REGISTRY OF RADIOACTIVE SEALED SOURCES AND DEVICES
SAFETY EVALUATION OF DEVICE

NO: AZ244S102B DATE: October 10, 2002
(Supersedes AZ-0806-S-118-G and AZ 244D102S)

DEVICE TYPE: Radioluminous Calibration Light Source

This is in response to your March 29, 1995, letter requesting technical guidance on two issues regarding an Arizona sealed source and device (SS&D) certificate.

40111

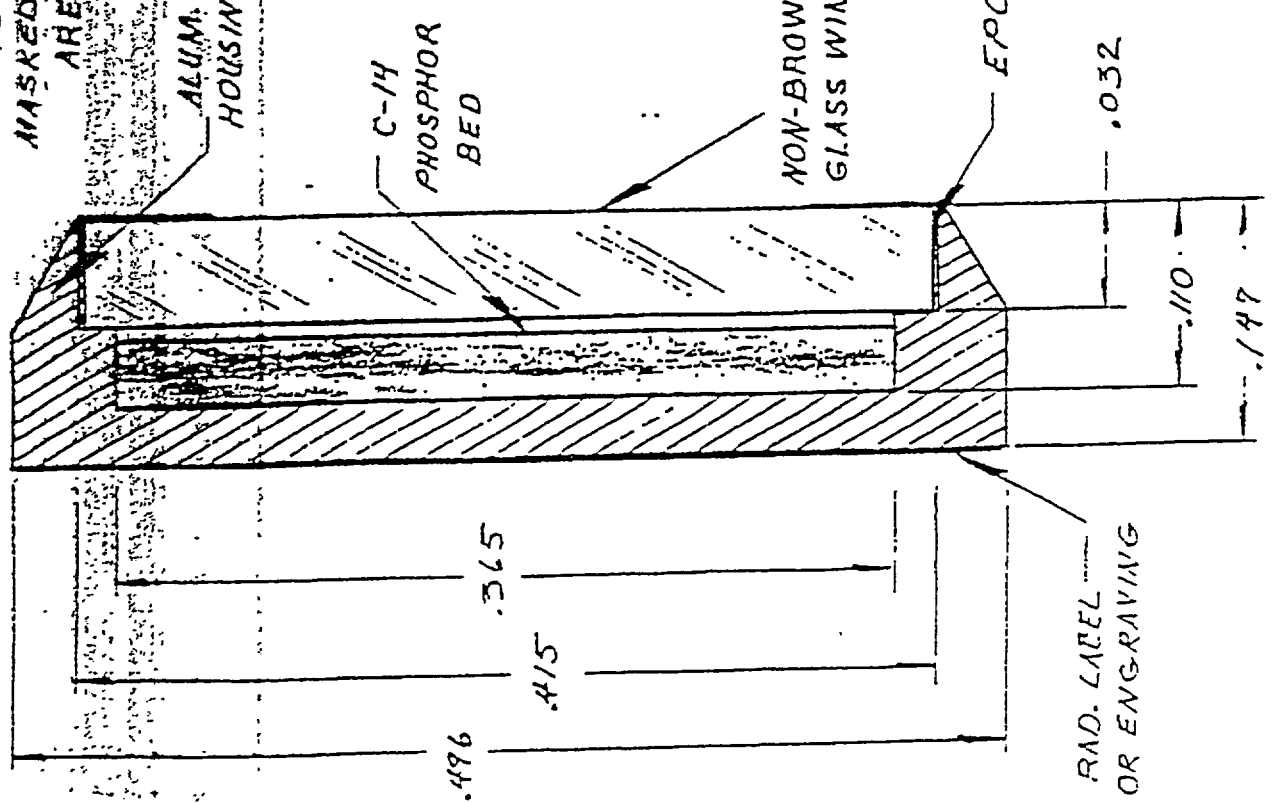
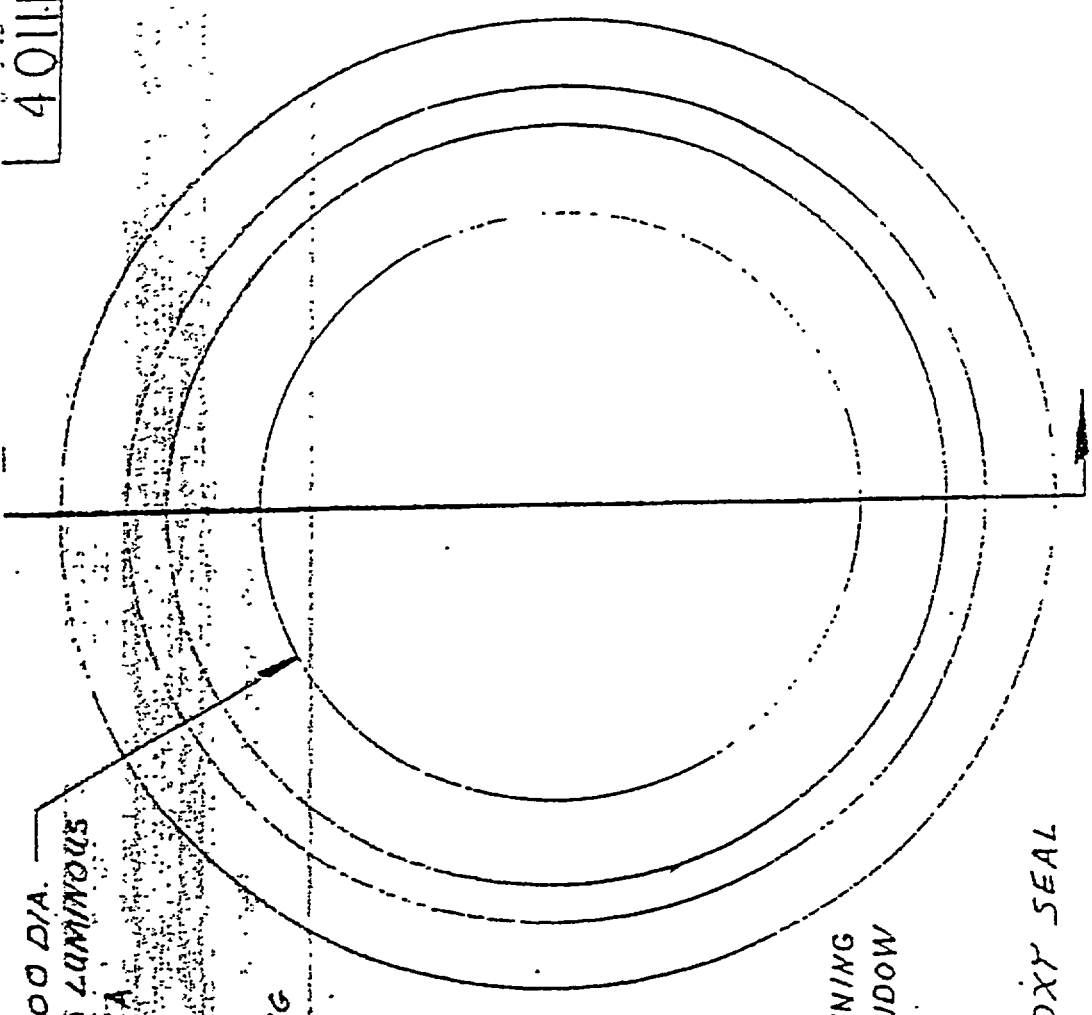
The AAC Model 40111 and the TLS Systems, Inc. Model 40108A Sources, based on drawings (Enclosures 2 and 3) are for all practical purposes identical, the latter model having current registration by this Agency. A suggestion would be to amend the Model 40108A registration to include the Model 40111.

Although the models seem to be very similar, the information provided by the State indicates the AAC Model 40111 is not identical to the TLS Model 40108A. We have been unable to obtain additional information from our files that would indicate that these sources are identical in design and construction.

The AAC Model 40111 sources should not be re-labeled as the TLS Model 40108A sources as these sources were manufactured by AAC and not TLS Systems, Inc. Licensing of these sources is based on the approval issued to AAC. Since there is currently no information that would indicate that these model sources are identical in design and construction, re-labeling the sources would invalidate that approval.

The ARRA amend an existing inactive source certificate issued to AAC to add the model 40111 source. This would be based on the information that ARRA currently has available, and would provide a basis for licensing the source for use. Also, this would be a lesser administrative burden than issuing a separate certificate for the 40111 source. When choosing a certificate to amend, the State should consider only certificates for source models similar in design, construction, and use to the model 40111 source (e.g., AZ-0806-S-118-G, for the 40108 I-lite source). The amended certificate should contain a listing of all known limitations of use for the model 40111 source (such as environmental use conditions or types of uses). Information provided by the State, TLS Systems, Inc., and Northrop-Grumman Corporation (an Air Force contractor who installs the sources) indicates the AAC model 40111 source was approved for uses similar to the currently registered TLS model 40108A I-Lite source. Therefore, wording in the current certificate for the model 40108A I-Lite source could be used as a basis for wording in the model 40111 source certificate.
